**Evaluating Operational Irregularities at Hanford's  
Environmental Restoration Disposal Facility - 8132**

This paper describes the findings of an independent technical review that investigated operational irregularities at the Environmental Restoration Disposal Facility (ERDF) at Hanford. The ERDF is a large-scale disposal facility authorized by the Environmental Protection Agency and the Washington State Department of Ecology to receive waste from Hanford cleanup activities. The irregularities included (i) failure to recognize that pumps for the leachate collection system were not functioning for an extended period and (ii) falsification of

**Fig. 2. Schematic of double liner at the ERDF.**

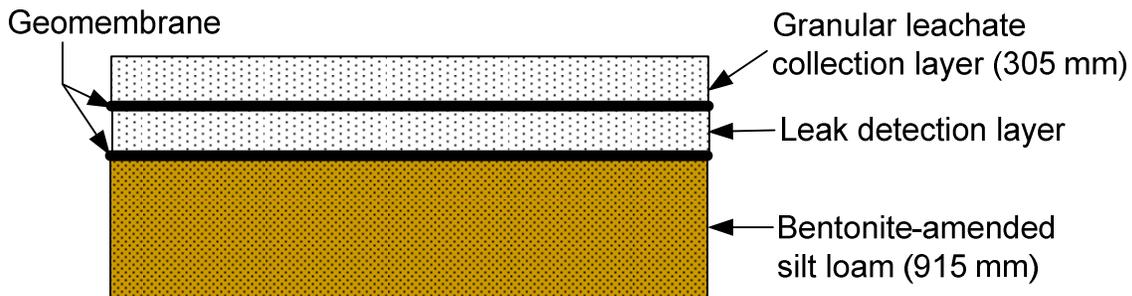
The contractor analyzed the impacts of the excessive leachate level by (i) comparing the quantity of liquid that collected in the leak detection zone (LDZ) relative to the action leakage rate (ALR) and (ii) examining the load placed on the lining system by the additional liquid in the landfill. However, neither of these analyses assessed the most significant impact associated with the elevated leachate level, i.e., did the excessive leachate level cause additional leakage from the ERDF?

An analysis of leakage would consider the amount of water that collected in the LDZ and determine the fraction of this water that leaked from the secondary liner in the ERDF. A comparison of the liquid quantity in the LDZ to the ALR (as done by the contractor) is inadequate alone, because this analysis does not consider that some of the liquid in the LDZ may have leaked from the secondary liner during the period when the pumps were not operational. Because the secondary liner employs a composite barrier system, any additional leakage due to the excessive leachate level probably was negligible (Fig. 2.). Nevertheless, the ITR team concluded that an analysis should be conducted to estimate the amount of additional leakage that occurred. The contractor conducted this analysis subsequently, and showed that the leakage was negligible.

**Fig.3. Conceptual design of the landfill and leachate system at the Hanford ERDF.**

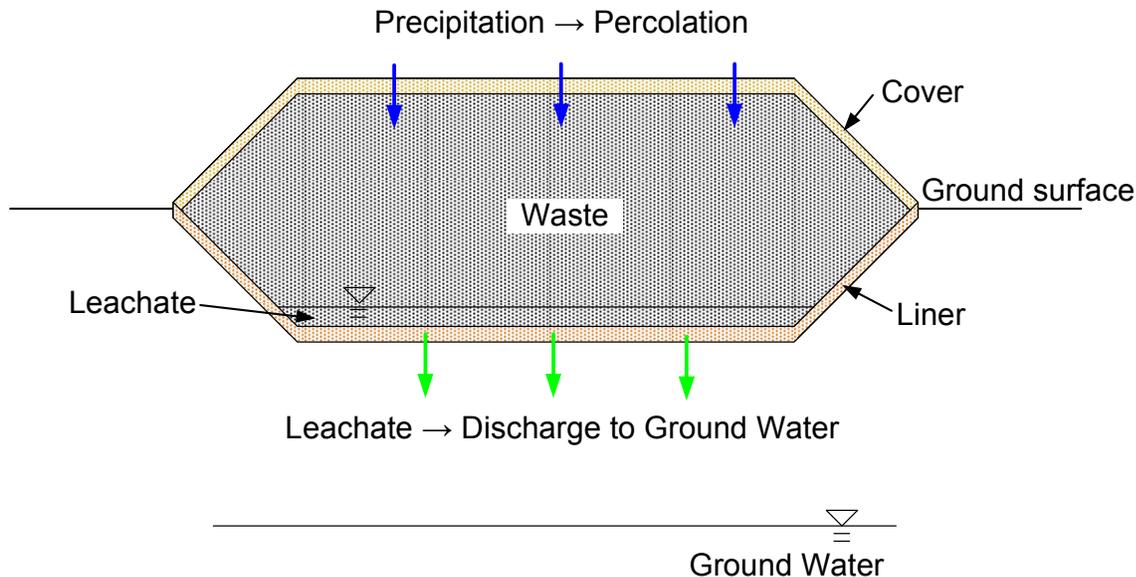
The most significant issue regarding waste compaction is whether the compacted waste fill in the ERDF will provide adequate support for the final cover. A schematic drawing of the conceptual landfill at ERDF is shown in Fig. 3. The final cover is a particularly important part of the ERDF, because the cover limits the amount of percolation that enters the waste and ultimately becomes leachate. Adequate waste density is crucial to ensure that the waste has sufficient stiffness to support the final cover with minimal settlement.
